Product Change Notice: DJ & HE Series CQC Standard Change

Product Group #: 3&4

DATE: 06.16.2026

PCN.PG.03.06.16.2026 DJ & HE Series CQC Standards Change Notice Affected Parts List

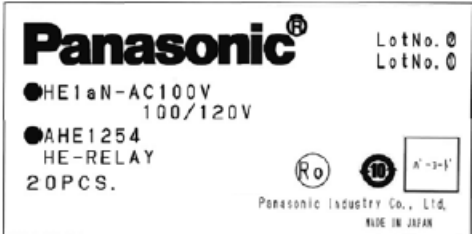
Change Details: The “CQC mark” has been removed from both the inner and outer carton for the HE and DJ series.

Label display: DJ relays

Before	After
Inner Carton	 Remove CQC mark	
Outer Carton	 Remove CQC mark
